Technical Service Bulletin

Subject: FRONT DOOR INTERFERES REAR DOOR GARNISH	Bulletin No.: 09-014/22
	Last Issued : 04/12/2022

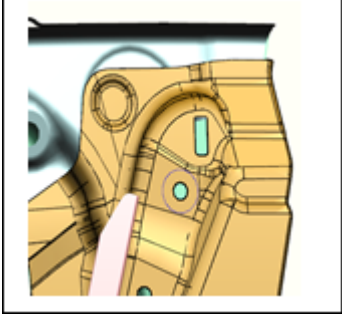
Some vehicles may exhibit that the glass run channel of the front door interferes with the rear door garnish.

Since the front door glass run channel is not fixed to the door strongly enough for the following situations, cycles of door operation may result in interference and lead to damage on the seal rubber at the rear door.

- When the front door glass is closed, the glass run channel may be forced to move to the B pillar side.
- In very hot climates, the glass run channel may expand to the B pillar side.

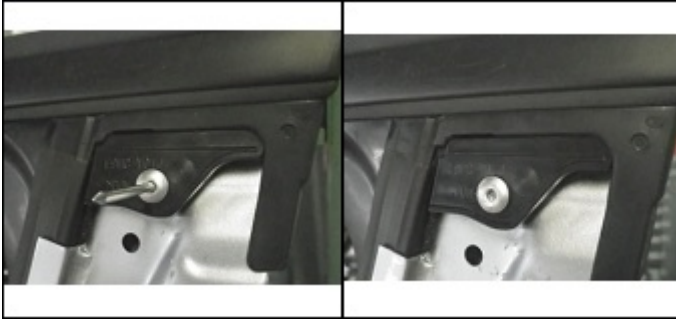
b. Remove the clip plate from a modified front door glass run-channel.

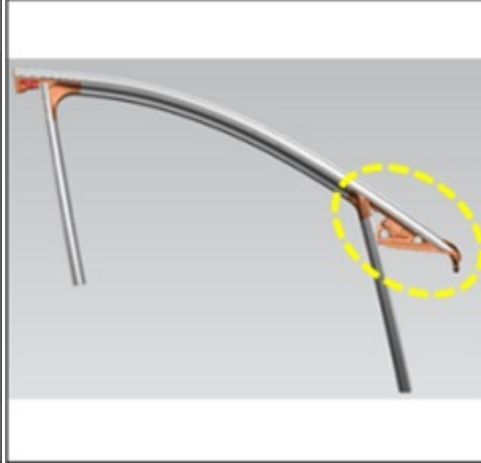
ATTENTION: There are two types of front door glass run channel.

- If the front door glass run channel obtained is BDMT-58/59-60ZJ or later level, remove and discard the sail garnish (1), which is originally installed on the vehicle according to the instructions on MGSS (SAIL GARNISH REMOVAL/INSTALLATION), before installing the front door glass run channel.
